Pikeview TR M-1977-211

Permit Amendment 4

Re: Technical Revision to Change to Post-Mining Land Use
Permit Amendment 4, Pikeview Quarry, M-1977-211

REQUEST FOR TECHNICAL REVISION (TR) COVER SHEET

Title
**EXHIBIT F-3
POST MINING LAND USE
AREAS**

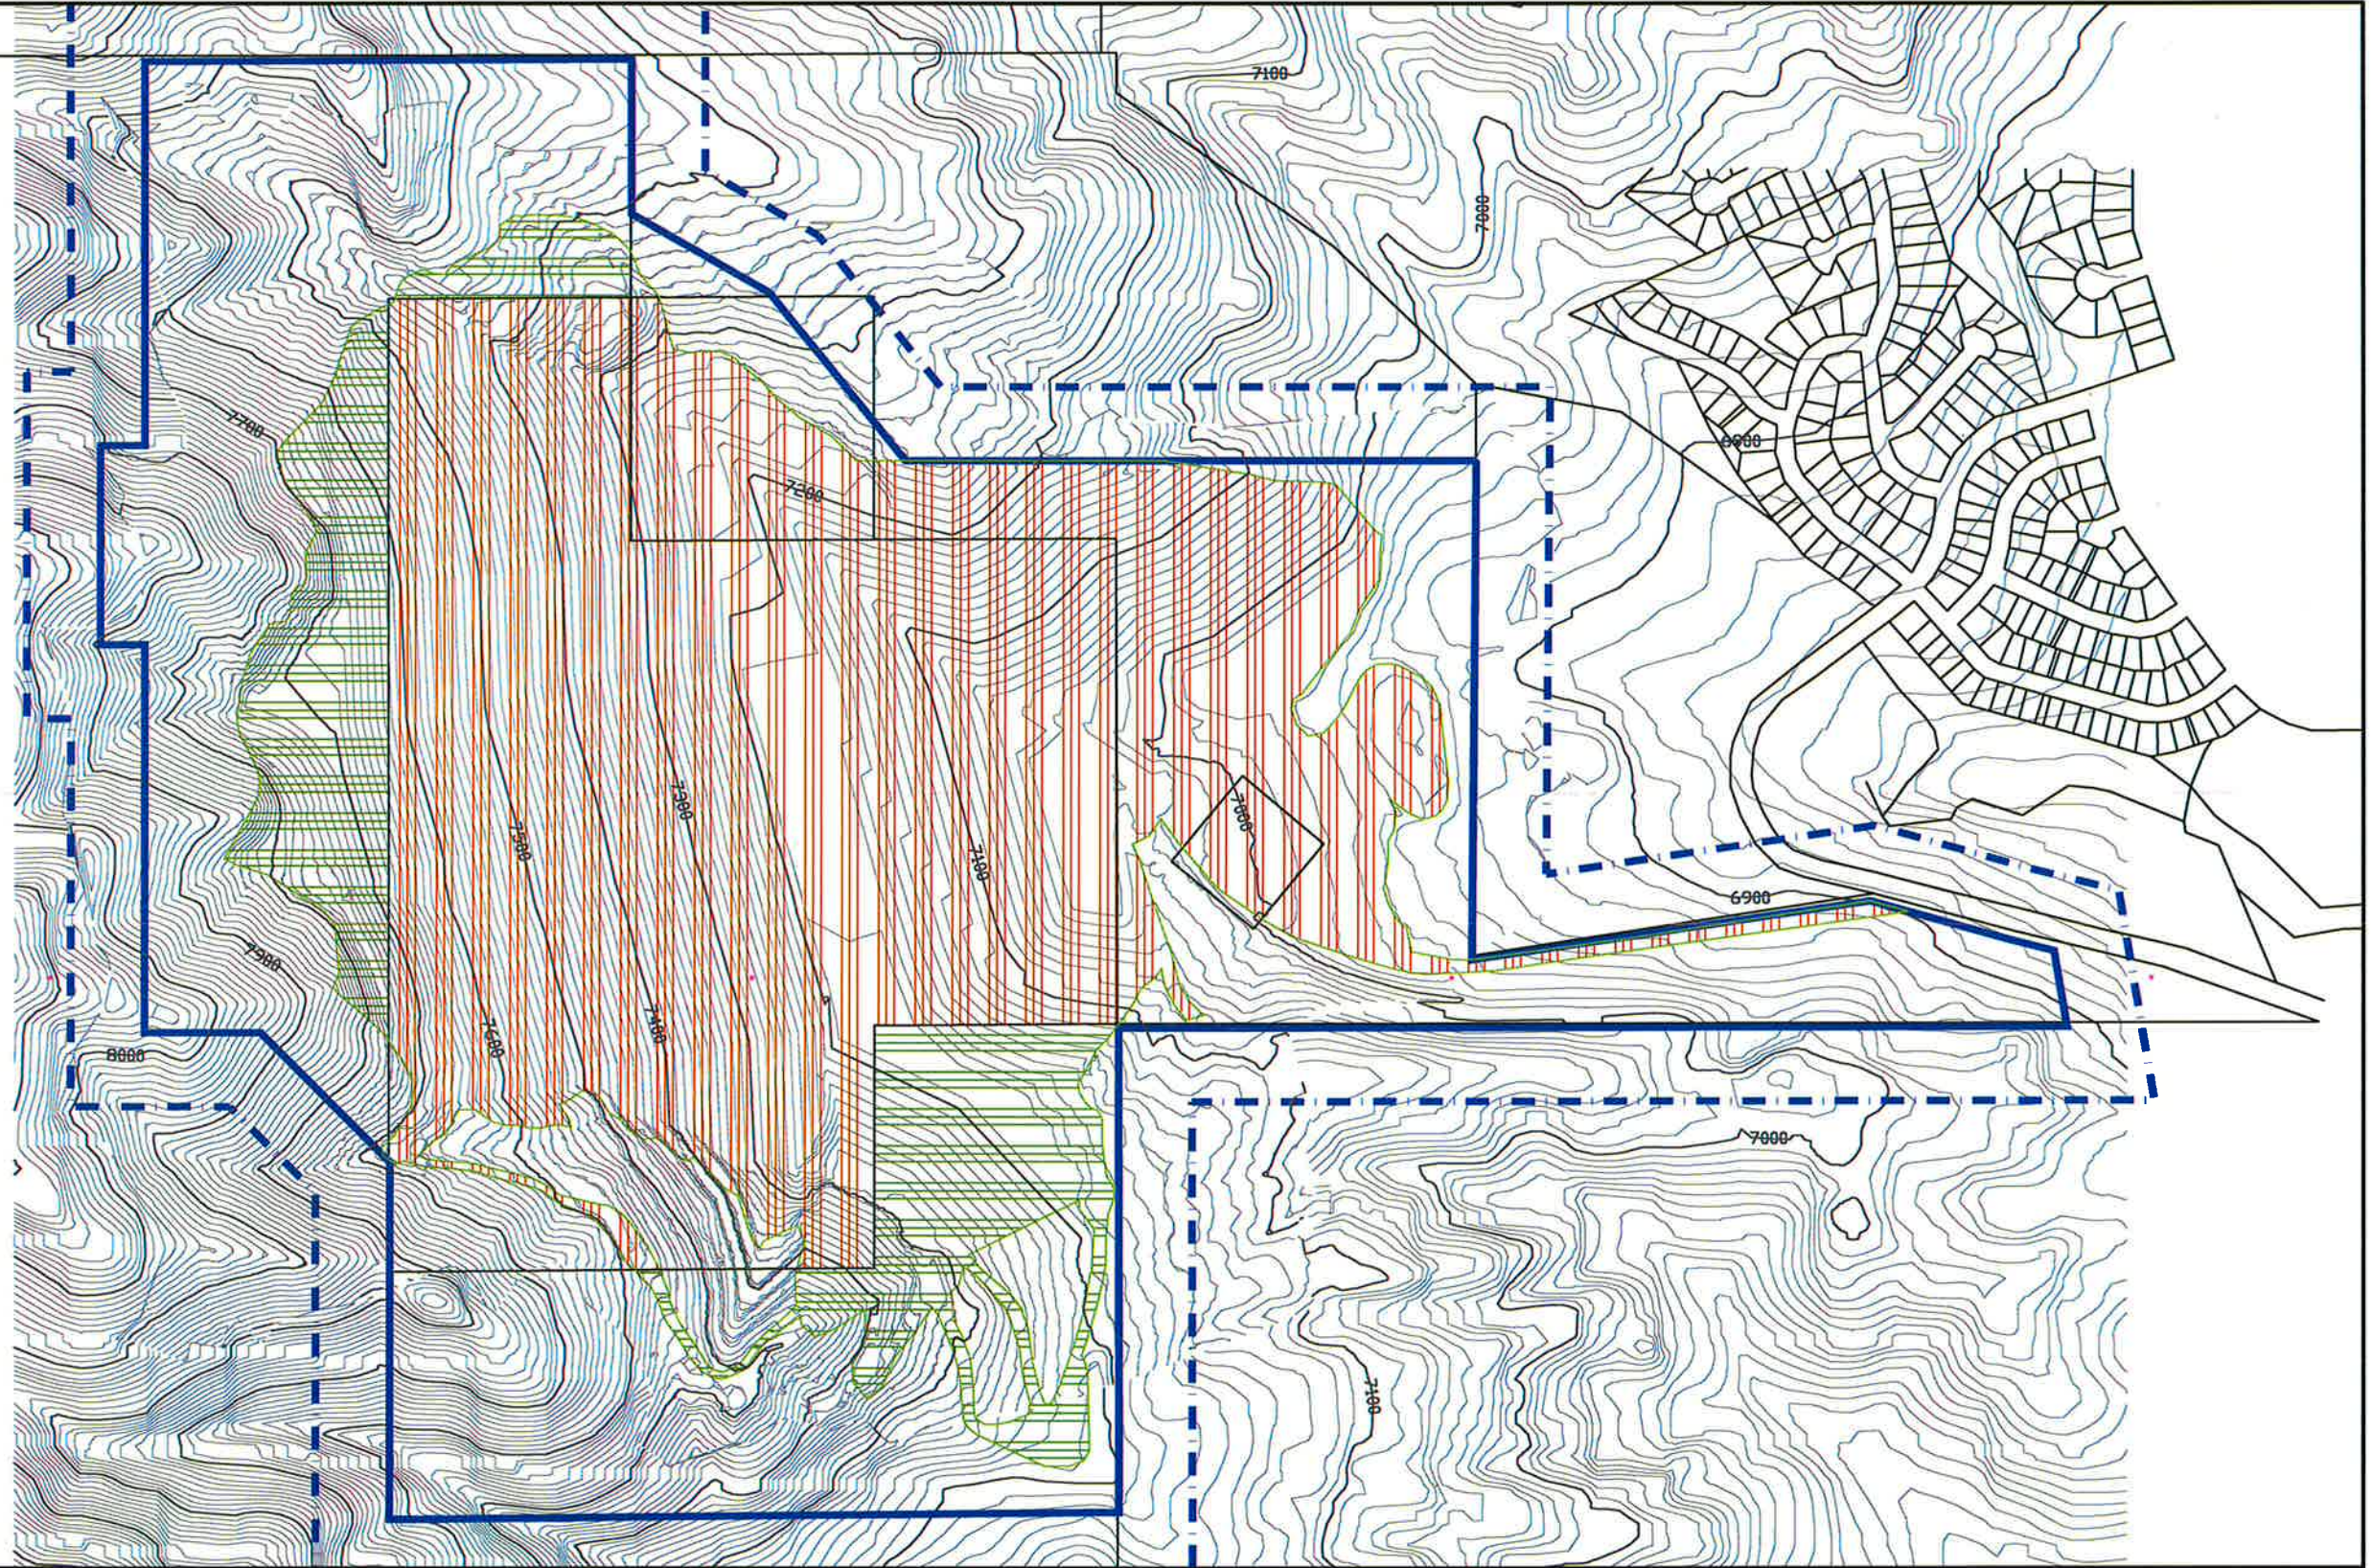
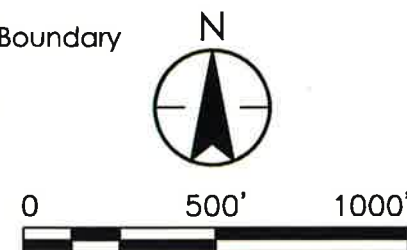
Here, simply acknowledging that portions of the land will likely be used in the future for recreation in addition to wildlife habitat has no effect on the substance of CMC's proposed reclamation plan. This change can be accomplished by simple edits to page 4 of the permit application form, the addition of a few sentences to Exhibit E to Amendment No. 4 (describing CMC's Reclamation Plan), and an additional map included in Exhibit F. The change will not require any further substantive alteration to CMC's permit

This TR proposes to add recreation as a post mining land use. The existing PMLU of wildlife

habitat will remain. No changes to the reclamation plan are required.

- Recreation and Wildlife Habitat PMLU (25.74 ac)
- Recreation PMLU (113.36 ac)
